April 12, 2016

STAFF REPORT ADDENDUM

PLANNED RESIDENTIAL COMMUNITY PRC 86-C-023-02

APPLICANT: Chick-fil-A, Inc.
ZONING: PRC, Planned Residential Community
PARCEL: 11-4 ((12)) 1B pt.
SITE AREA: 33,505 square feet
PLAN MAP: Residential Planned Community
PROPOSAL: To permit a fast food restaurant

Figure 2: Additional landscaping, Source: Sheet 12 of PRC Plan

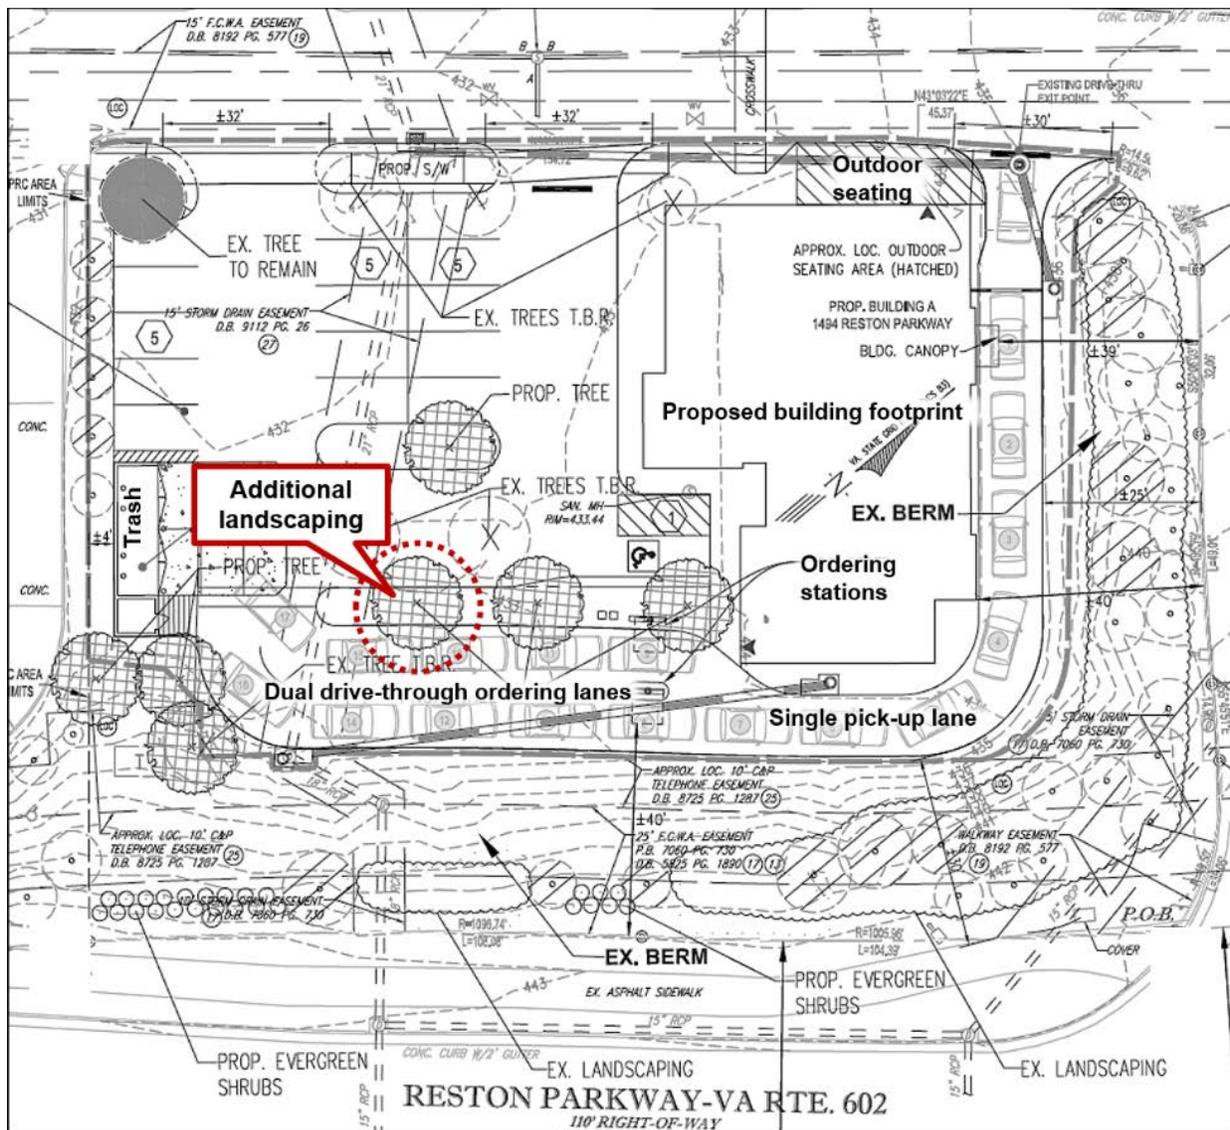
In the southeastern area of the site, for added screening, an additional interior parking lot landscaping tree has been added to the island that separates the drive-through ordering lanes from the parking area, as shown in Figure 2.

In addition, Note 4 has been added to the notes section on Sheet 12 of the PRC Plan to indicate that existing non-native and/or invasive species plantings may be removed and replaced with non-invasive species. The proposed PRC development conditions includes a condition for use of native and non-invasive species plantings for landscaping and other plantings on-site.

Figure 3: Comparison of the change to the building footprint, Source: PRC Plan

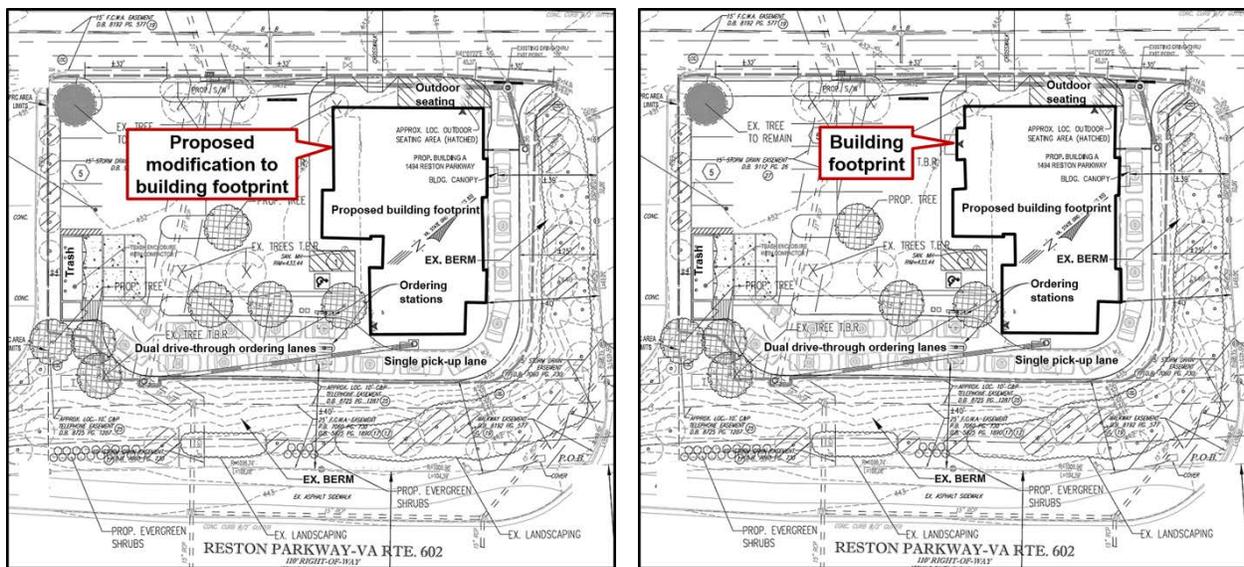
The building footprint has been modified to eliminate the entrance vestibule. The entrance will remain in this area but will be flush with the building, as shown in the PRC Plan. There is no change to the proposed square footage of the building, which remains at 4,701 square feet. Figure 3 provides a comparison of the proposed change to the building footprint with the previously shown footprint.
